EATON PUBLIC LIBRARY EXPANSION
132 MAPLE AVENUE
EATON, COLORADO 80615

ADDENDUM #2
APRIL 25, 2014

EATON LIBRARY EXPANSION
 ADDITION OF 10' X 10' CONCRETE PAD, ADDITION OF (2) ORNAMENTAL GRASSES, LAYOUT ADJUSTMENTS
 L01, L02
 APRIL 25, 2014
 1" = 10'-0"

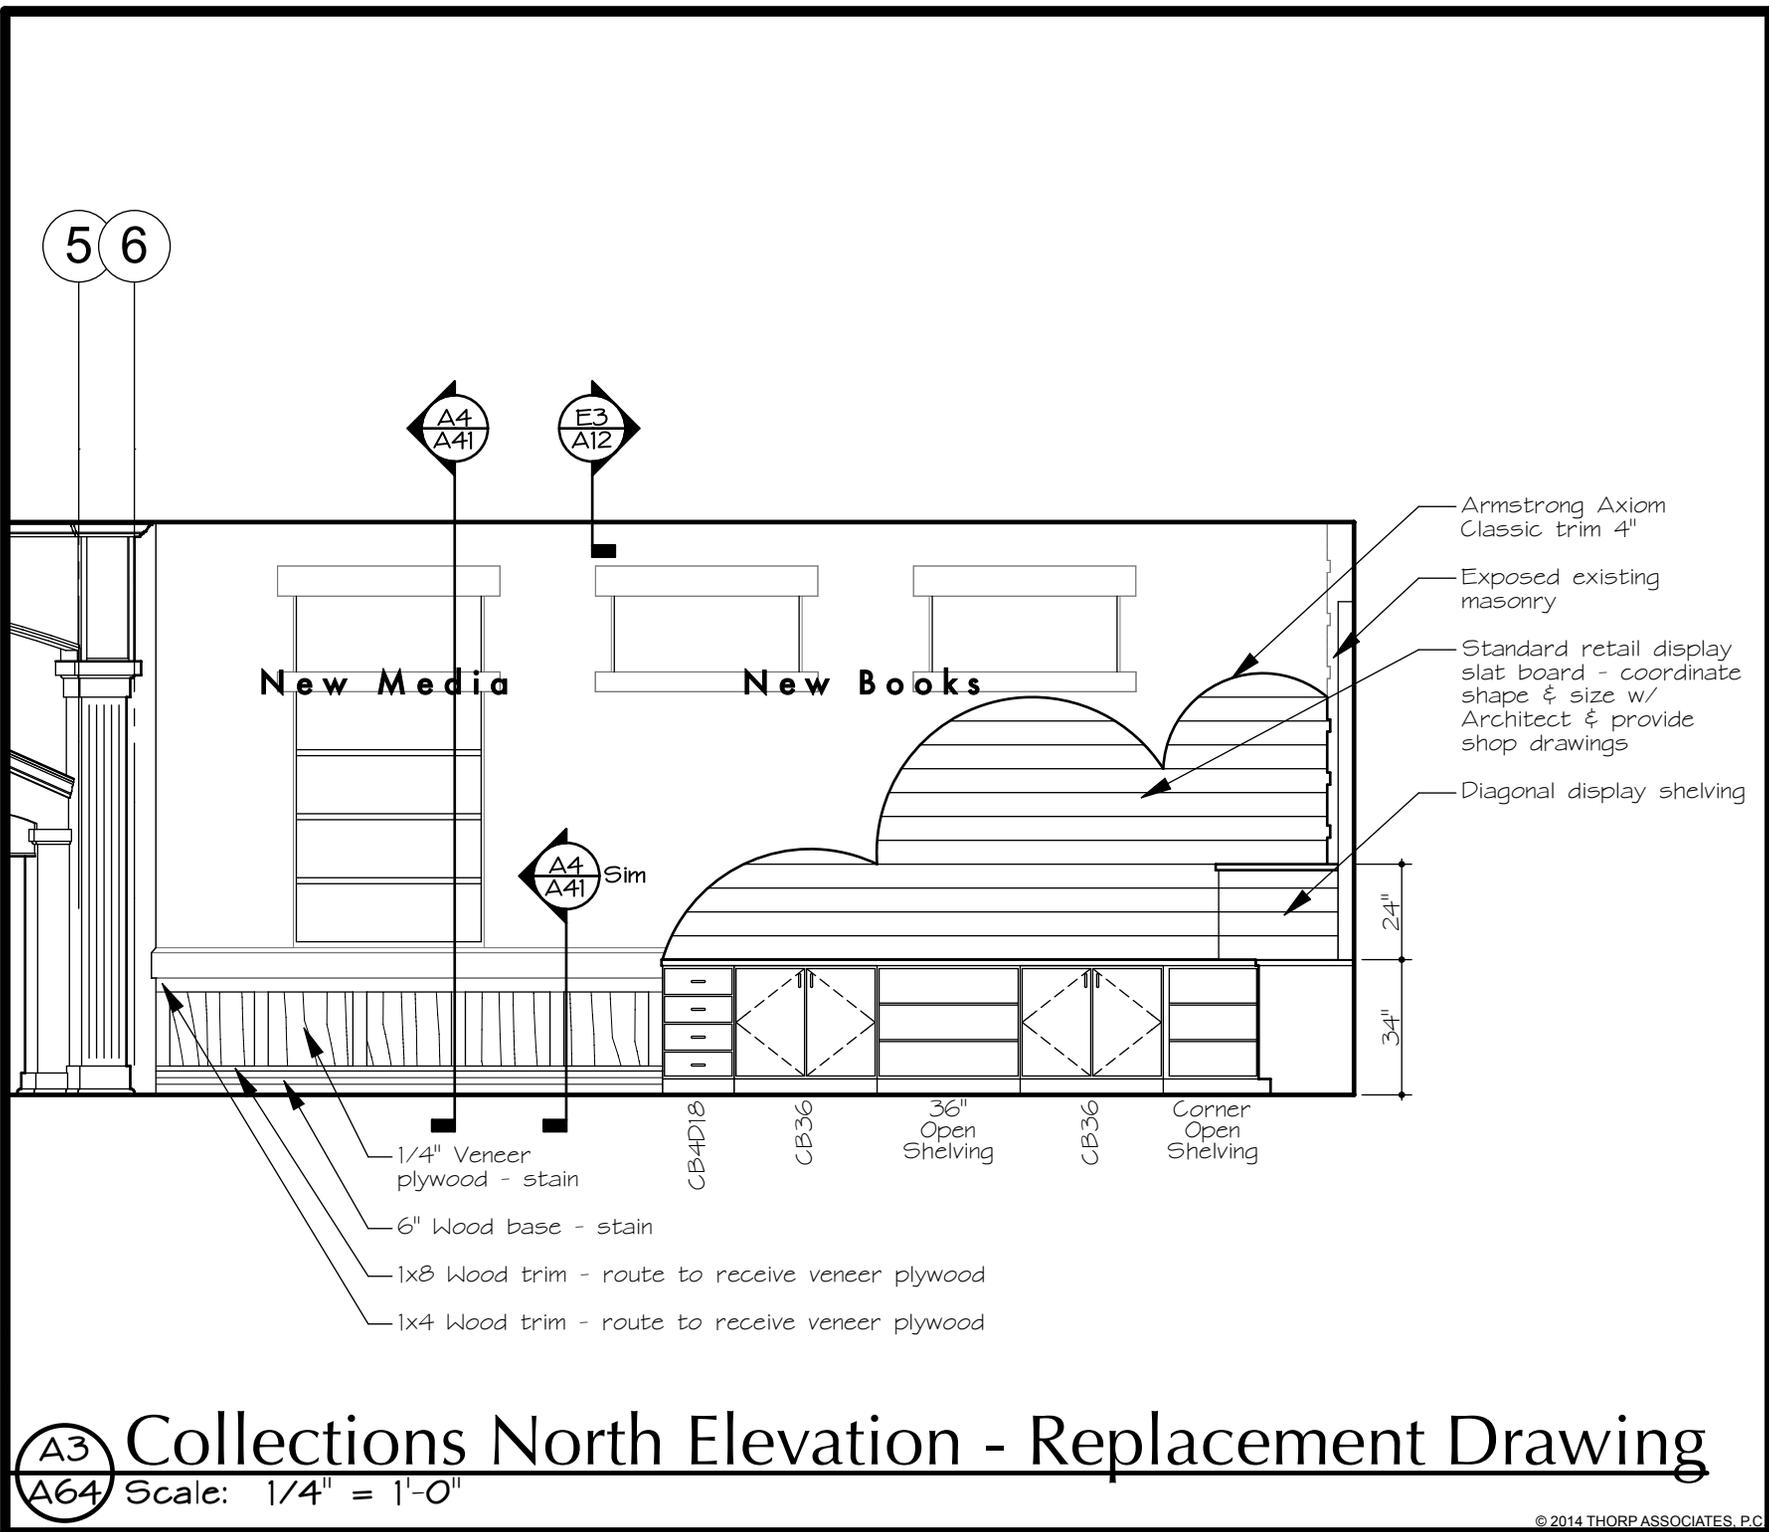
1. Sheets L01 and A00 SITE PLAN A3/A00: See attached drawings by BHA Design Inc. for revised entry concrete slab and landscaping layout.

A3 Collections North Elevation - Replacement Drawing
A64 Scale: 1/4" = 1'-0"

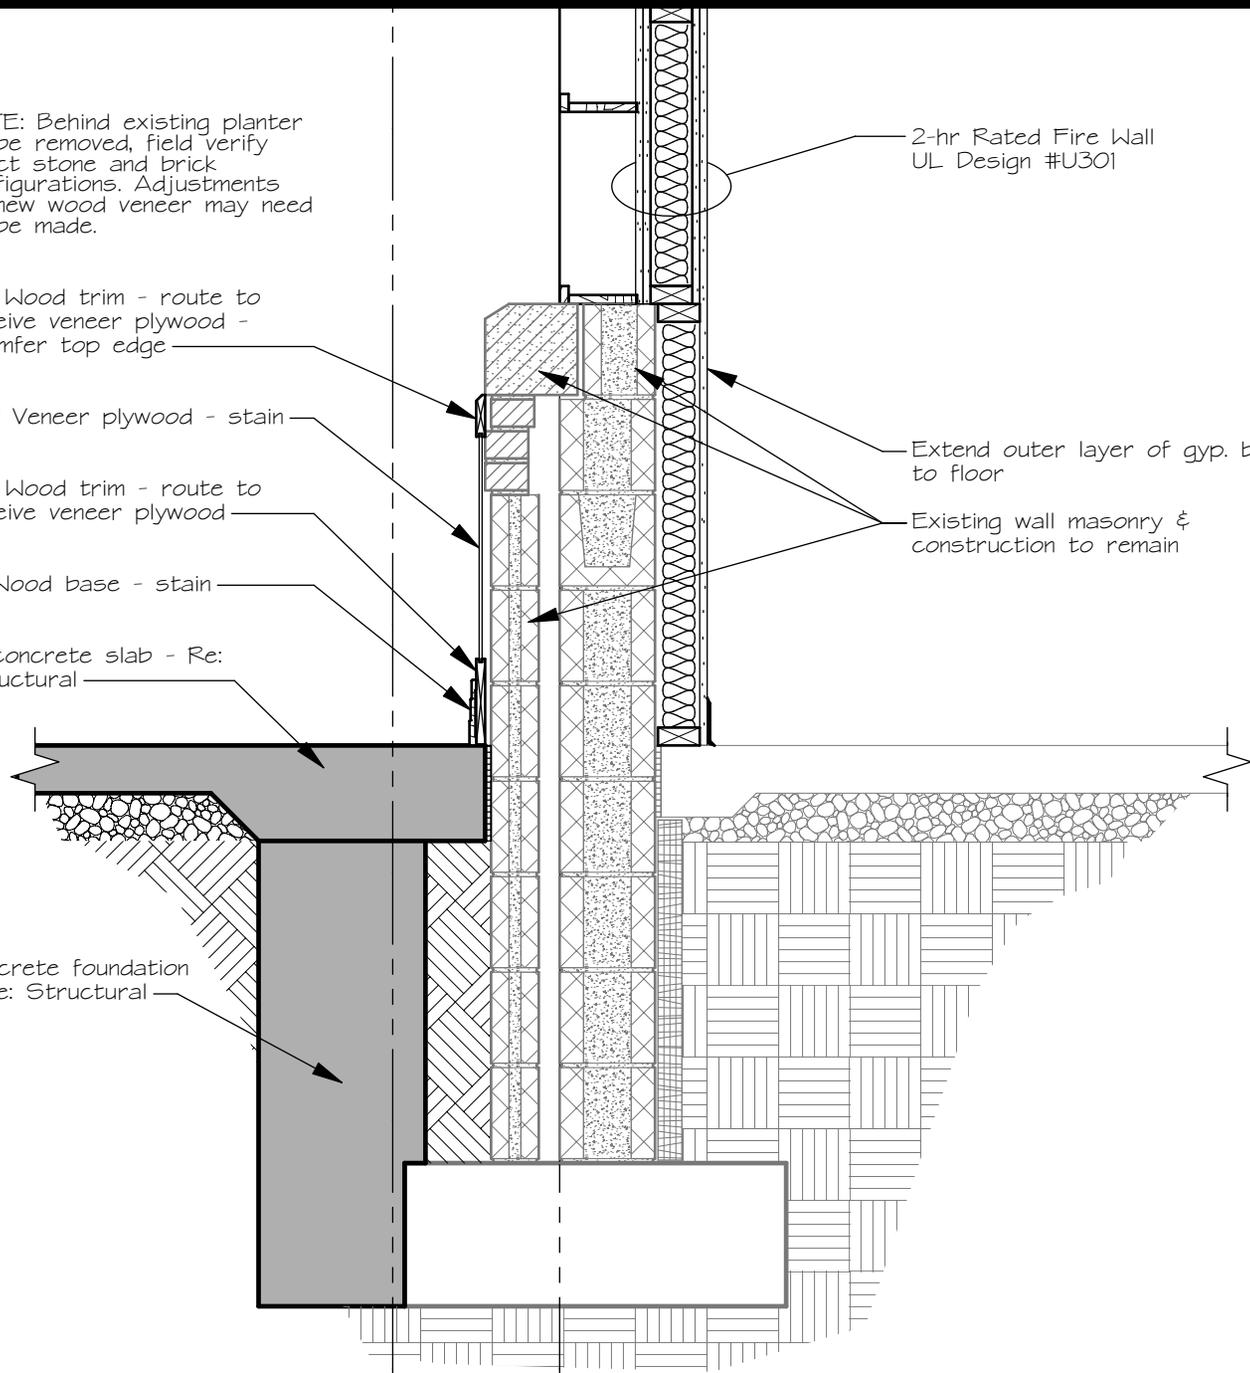
1. Section A4/A41 and Elevation A3/64: See Attached “Similar” detail of added wood wainscot where cabinets are not detailed. (See Replacement Elevation A3/A64 attached.)

1. At Detail A3/A64, the Axiom trim called out is the same product specified in Section 09 20 00, Paragraph 2.02. G, except that it is the 4” deep profile (minimum radius = 24”).
